To: T10 Technical Committee
From: Bob Sheffield(robert.l.sheffield@intel.com)
Date: 12 July 2006
Subject: 06-216r2: SAT - Block Mapping Issues

Overview

Figure 8 — REASSIGN BLOCKS command translation

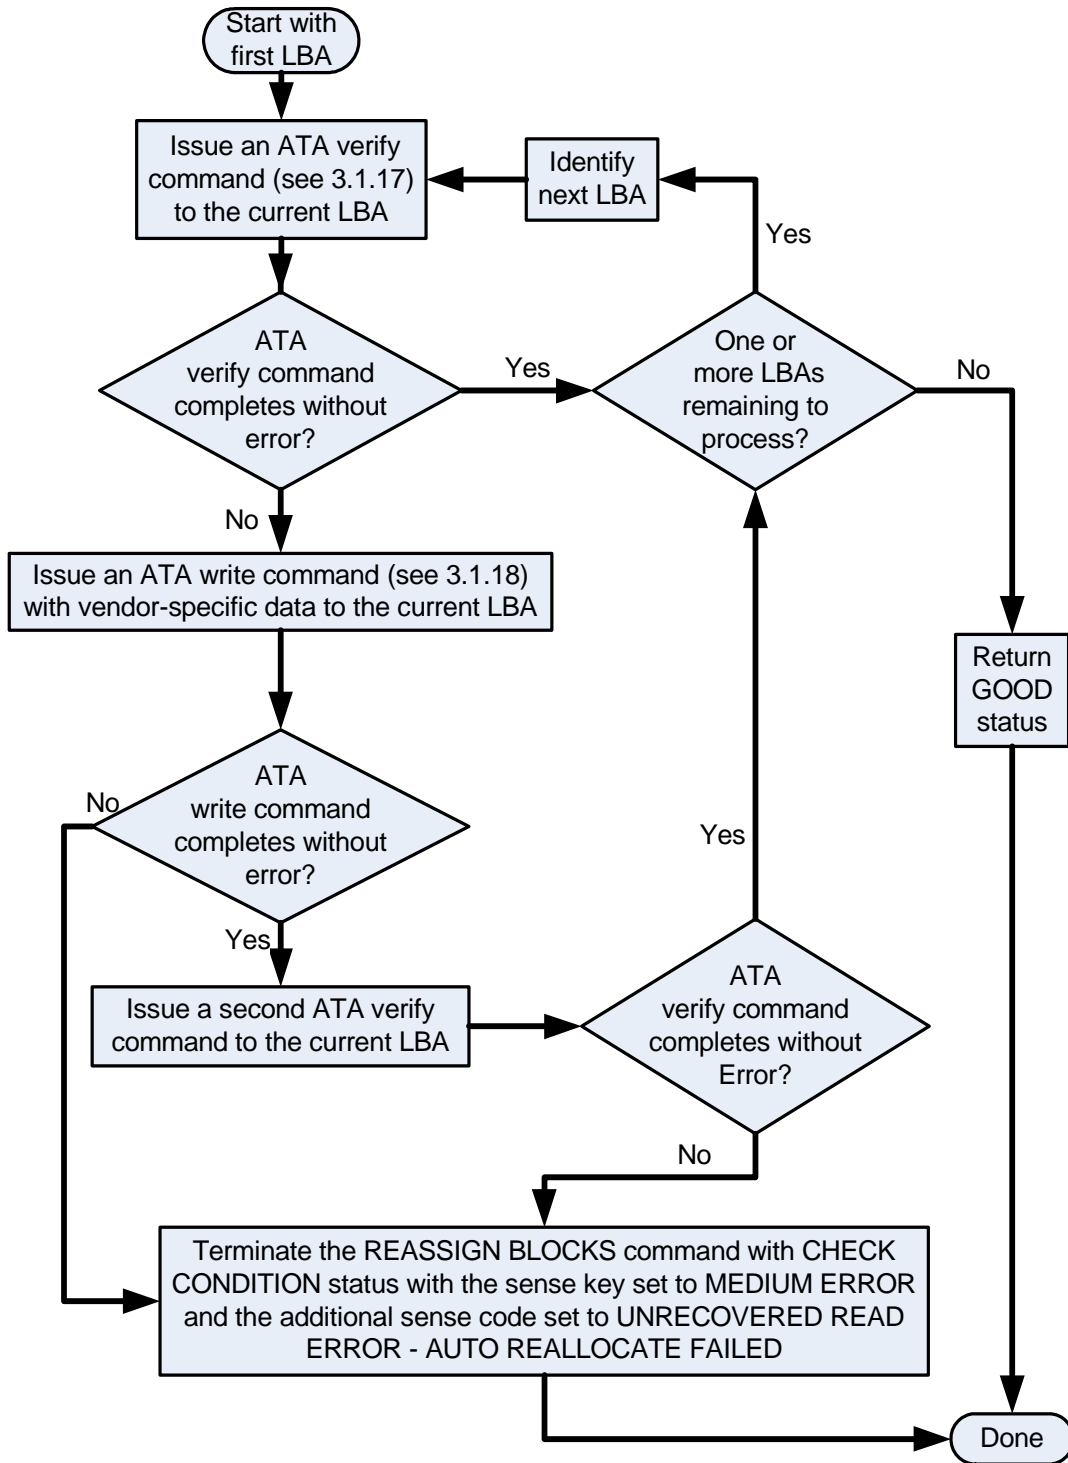
The REASSIGN BLOCKS command parameter list ~~provided in the data-out buffer transferred from the application client~~ contains the LBAs ~~of logical blocks~~ to be reassigned. ~~The LBAs provided in the parameter list shall be utilized for the LBAs in any ATA verify commands (see 3.1.17) or ATA write commands (see 3.1.18) issued by the SATL.~~

If the SATL implements direct block mapping (see 9.1.2), then the values set by the SATL in the ATA LBA of the ATA verify command(s) and ATA write command(s) shall equal the value(s) of the LBAs in the parameter list. Otherwise, the mapping is unspecified (see 3.4.3).

The SATL shall process each ATA LBA corresponding to LBAs specified in the parameter list as shown in figure 8.
